# FINAL DRAINAGE REPORT FOR RETREAT AT TIMBERRIDGE FILING NO. 2

619 N. CASCADE AVE SUITE 200 COLORADO SPRINGS CO 80903 (719) 785-0790 **Engineering Review**

PCD Project No. SF-21-021

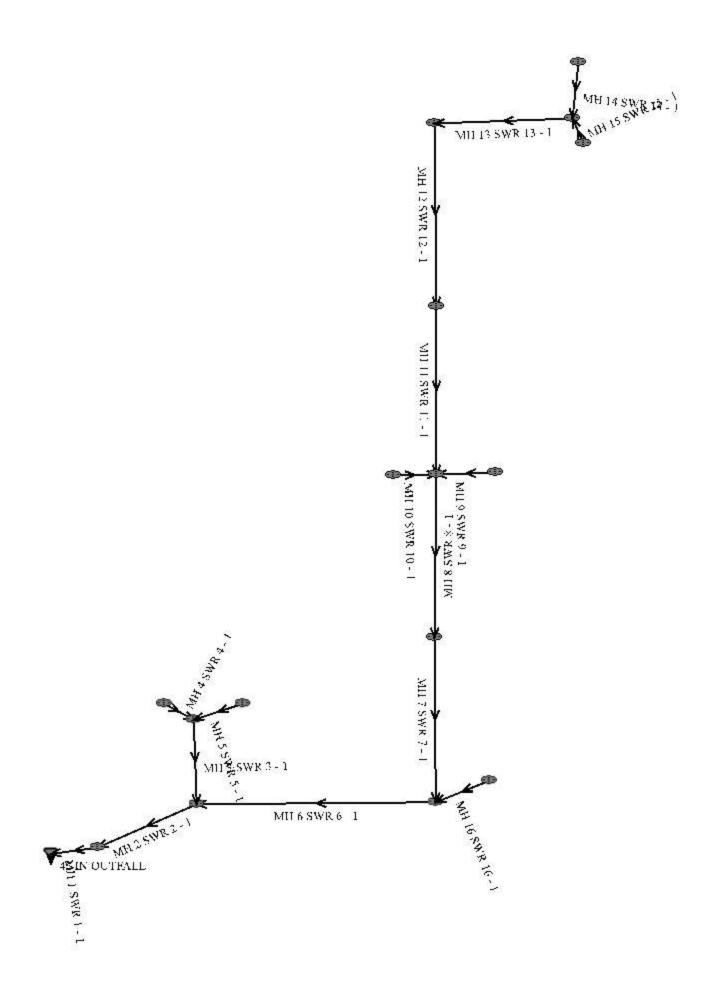
What is velocity in swale? Any lining any needed?

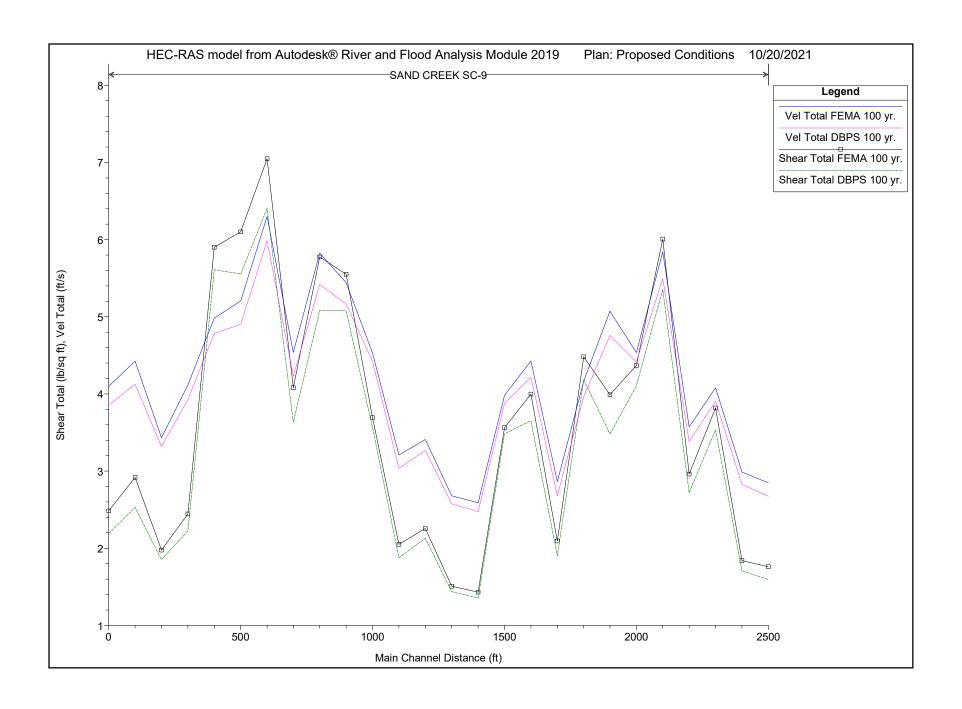
Grade control required?

MHFD has acceptable criteria; address channel design and stability.
